APPLICABILITY: 2018MY Forester Models **NUMBER:** 12-227-17

SUBJECT: Upper Front Grille- Design Change **DATE:** 08/29/17

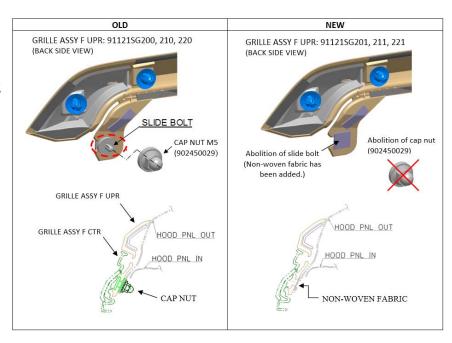
This Service Information bulletin announces a design change made to the upper front grille. The two small retaining slide bolts /cap nuts previously used have been eliminated.

As shown in the detail illustrations to the right, the following new FRONT GRILLE ASSEMBLY, UPPER part numbers now have non-woven tape applied over the slot where the bolts /cap nuts were used previously:

- 91121SG201
- 91121SG211
- 91121SG221

- If the replacement grille being used <u>has non-woven material covering the slide bolt slot</u>, there is no need to install the slide bolt / cap nut.
- If the replacement grille being used <u>DOES NOT have non-woven material covering the slide</u> <u>bolt slot</u> and utilized a slide bolt / cap nut, they must be reused or replaced if damaged or missing.
